ADDENDUM NO. 4

PROJECT: **Village of Gurnee Public Works Material Bin Reconstruction Project**

OWNER: VILLAGE OF GURNEE

Drawing No. **A2-1**

1 FLOOR PLAN
A2-1 1/8" = 1'-0"

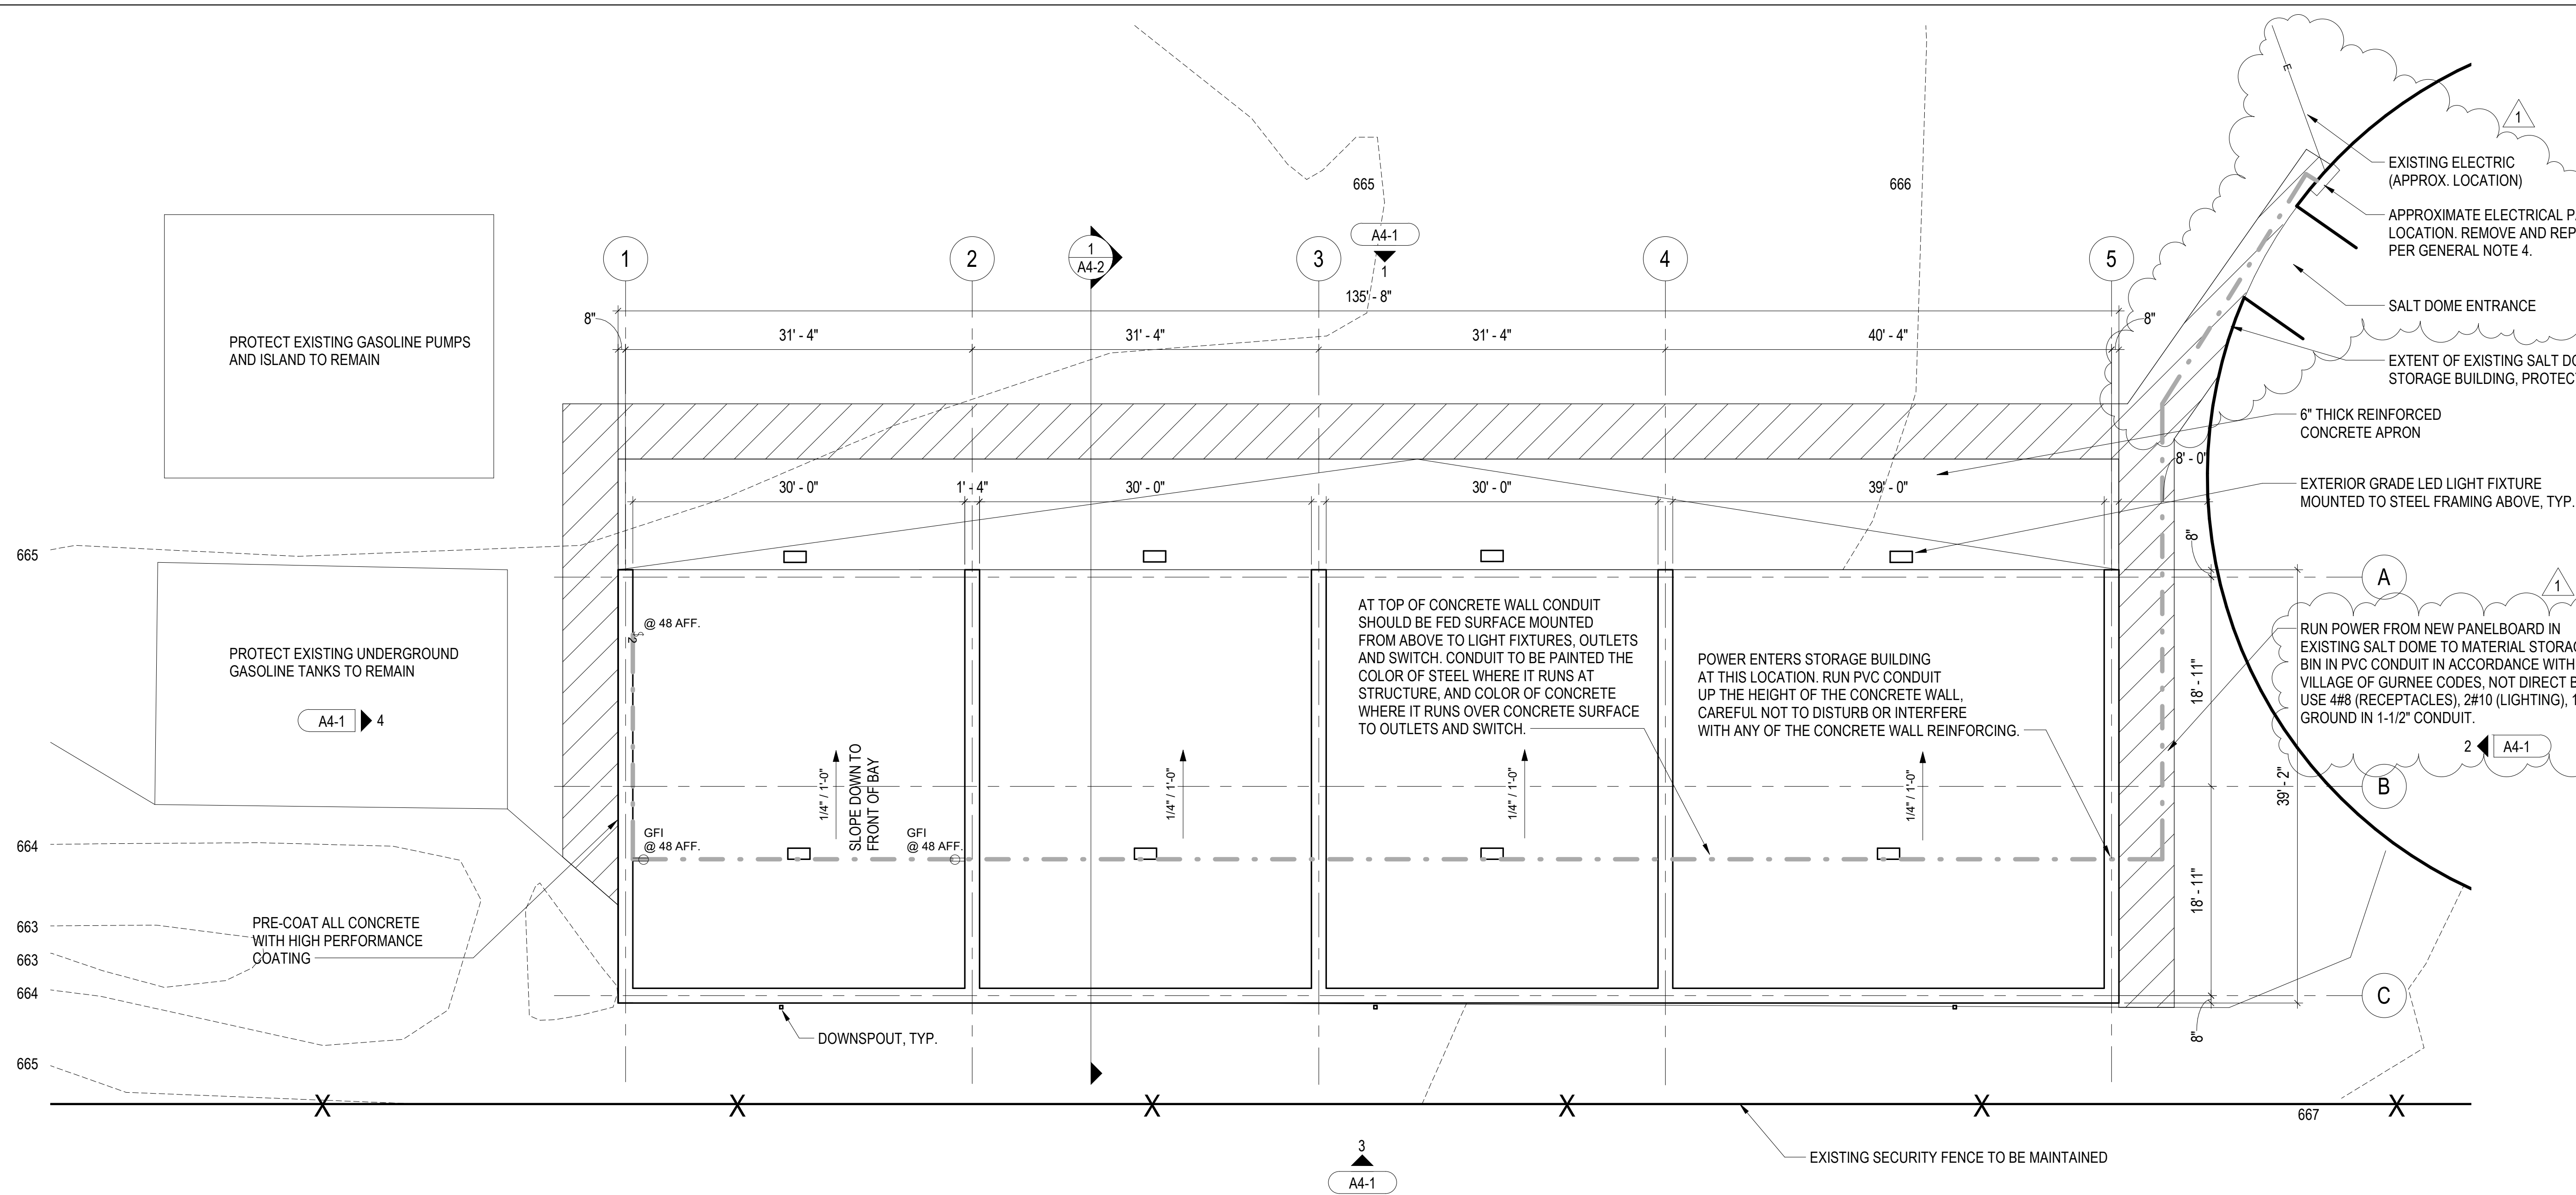
- **QUESTION:** What is the material between the new panel and the new foundation? There is a new asphalt apron around the Material Bins but for installing the new electric feeds to the building, can it be trenched? Or does it need to be saw cut and patched?
- **RESPONSE:** The existing paved parking lot is asphalt. The electric service installation between the salt dome and the new material bins can be directionally drilled or open cut. If the selected method is open cut, existing pavement must be saw cut and then properly patched prior to asphalt plants closing for the season. Cold patch will not be accepted since this area is directly in front of the entrance to the salt dome and will experience repetitive high loads when salt is loaded/unloaded during snow and ice operations. Hatching has been added to sheet A2-1 to outline the pavement restoration area for an open cut installation.

Item 3: Modification to Plan Sheet A2-1(see attached)

- Wiring installed from the new panelboard on the existing salt dome to the material storage bin shall be installed in PVC conduit in accordance with Village of Gurnee codes, NOT direct bury
- Conduit shall be 1.5 inches in diameter.
- The wiring within that conduit shall be 4 #8 wire for the receptacles, 2 #10 wire for the lighting and 1 #8 wire for ground.
